MAGIC CARPET SAFETY SERVICE BULLETIN
March 13, 2008

SERVICE BULLETIN 2008-01

Scope: All Magic Carpet Lifts Using Allen Bradley Micro Logix PLC Controls. Manufacture Dates 2002-2006

Subject: Electrical Wiring Modification For Monitoring PLC run input command.

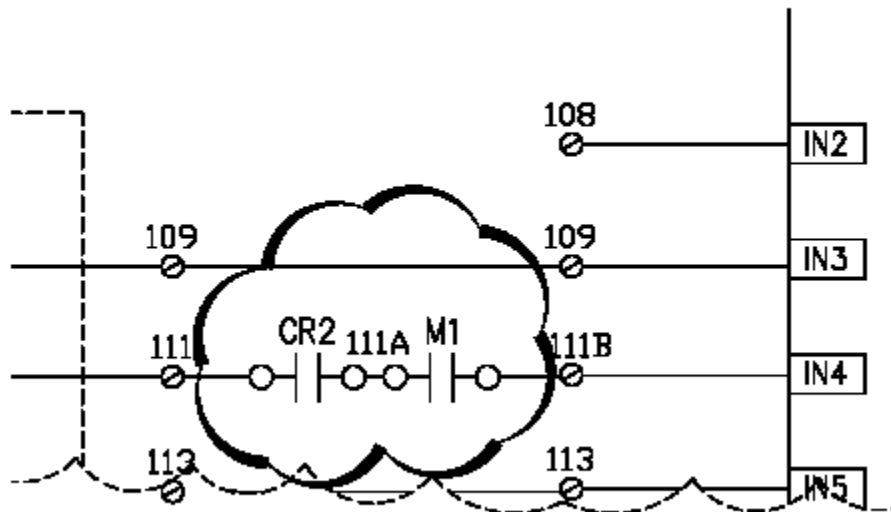
Test procedure remove the wire from the M1 contactor coil and observe that the lift stops then reattach the wire and observe that the lift does not start. Repeat the test procedure on the CR2 coil wire.

**OPTION 1-
RUN WITH MAINTAINED KEY SWITCH -10 SECONDS**

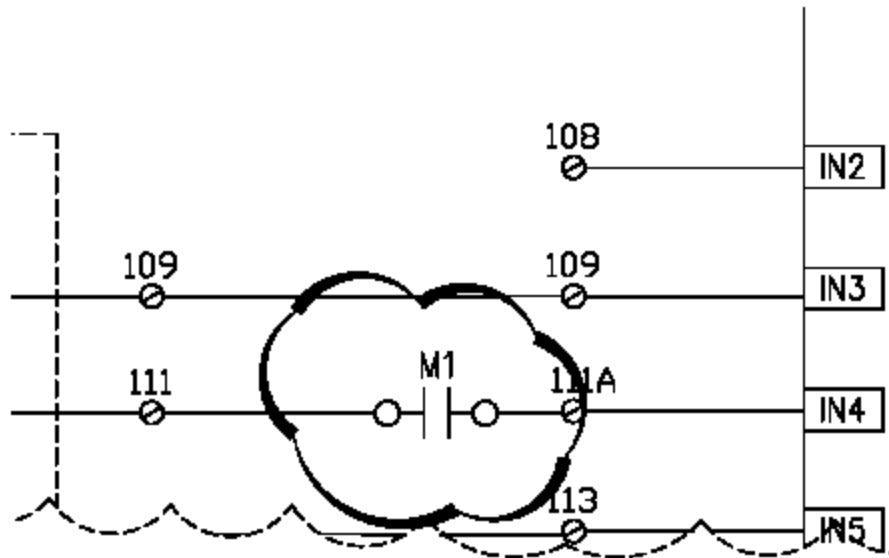
Wiring change at the PLC. Input 4 of the PLC, wire #111, is to be removed and connected to CR2, NO contact. A new wire is to be installed to this NO contact, wire #111A and run to M1, NO contact. From this contact block a new wire #111B is to be installed in the PLC at input 4, formerly where wire #111 was terminated.

OPTION 2 RUN WITH MOMENTARY KEY SWITCH

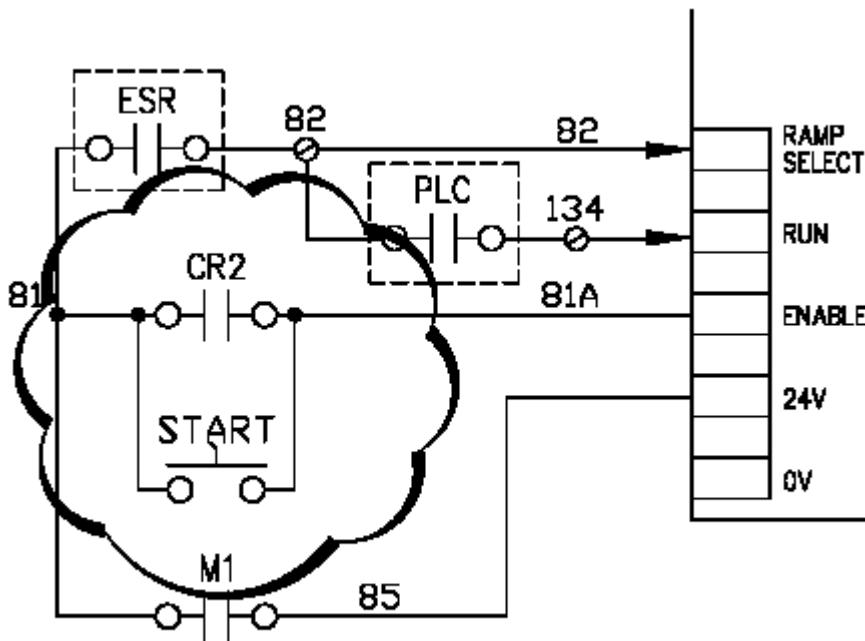
This change is at the PLC. Input 4 of the PLC, wire #111, is to be removed and connected to M1, NO contact. A new wire is to be installed to this NO contact, wire #111A and installed in the PLC at input 4, formerly where wire #111 was terminated.

This change is at the VFD. Wire 81 goes to CR2, NO contact and a new momentary contact in the key switch, actuated when the key switch is in the START position. New wire 81A is wired in parallel with the output of these two contacts. Wire 81A terminates on the AC VFD where 81 was formerly terminated.
